Golder Associates Inc.

February 3, 2000

RE: Palmetto Power, L.L.C.
DEP File No. 0970073-001-AC (PSD-FL-277)
Information Request

NO_x Emissions by Operating Load

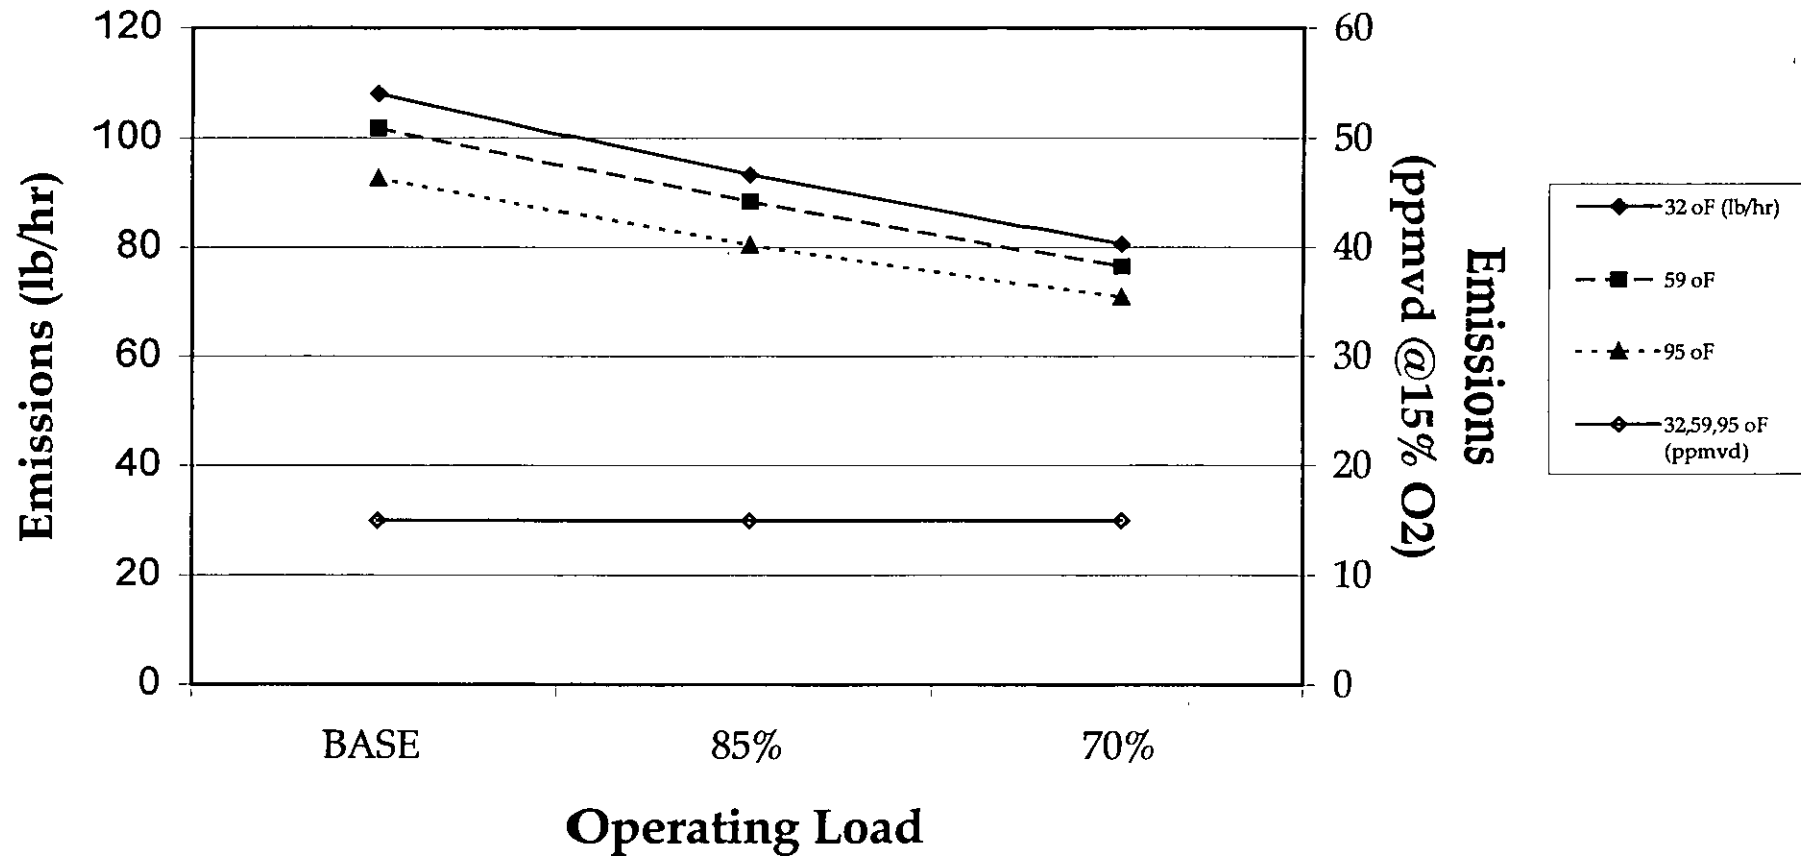
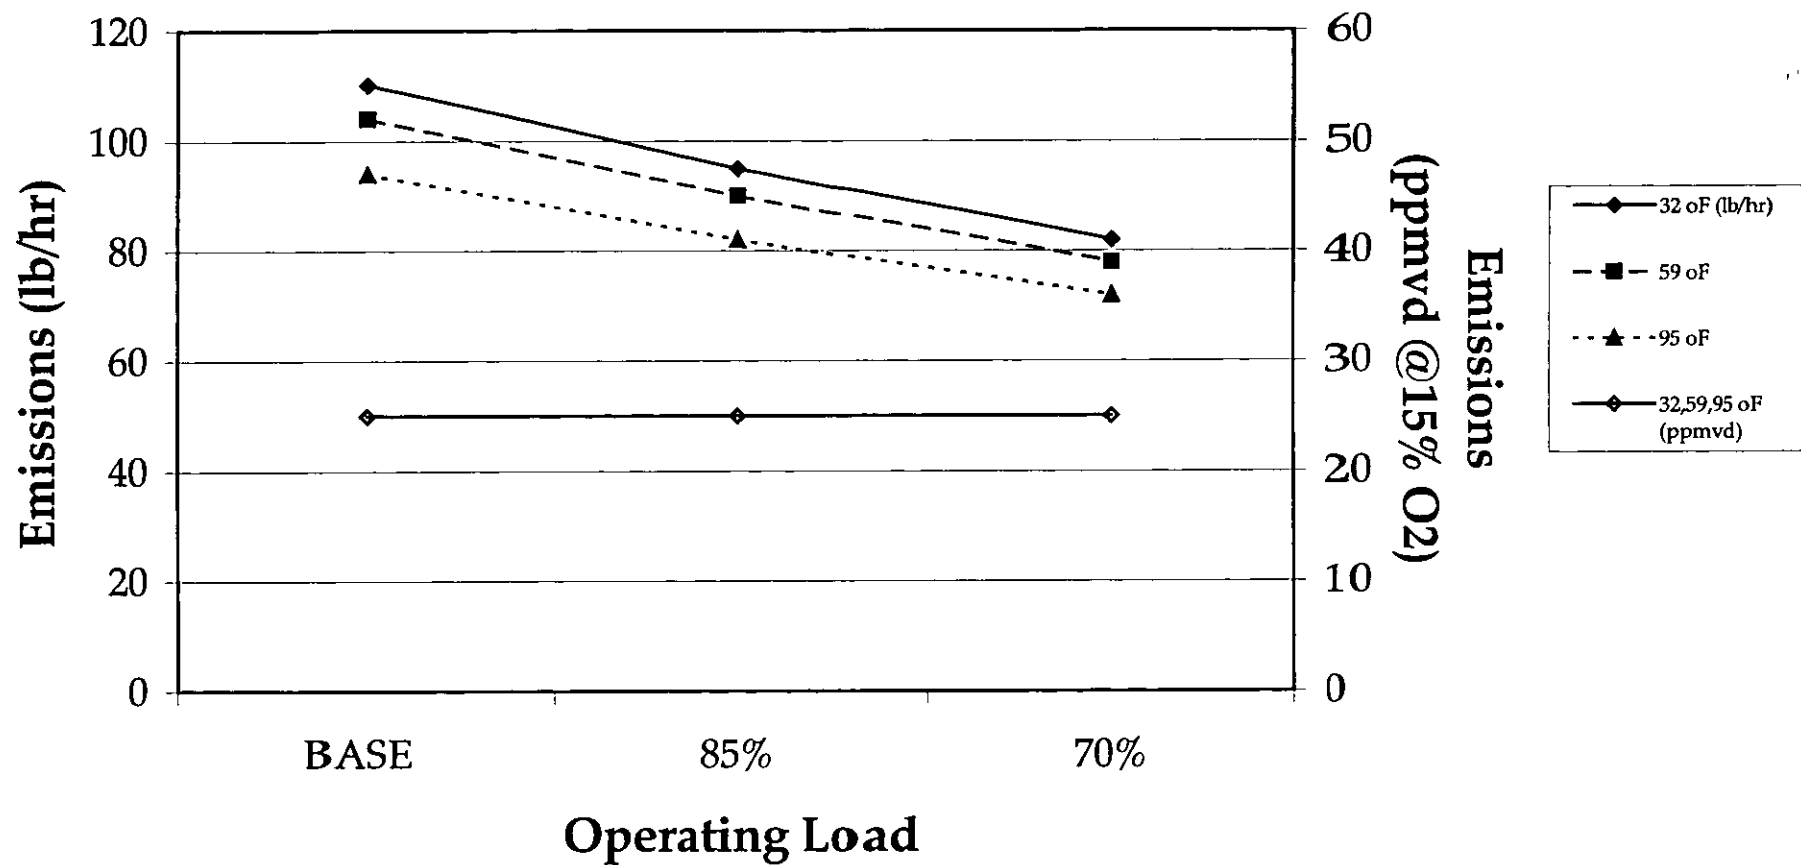
4. Department's Information Request: Please provide emissions performance curves based on manufacturer information for:

- CO vs. load in terms of ppmvd and pounds per hour
- NO_x vs. load in terms of ppmvd and pounds per hour

Palmetto Power Response: Performance curves for the project are attached.
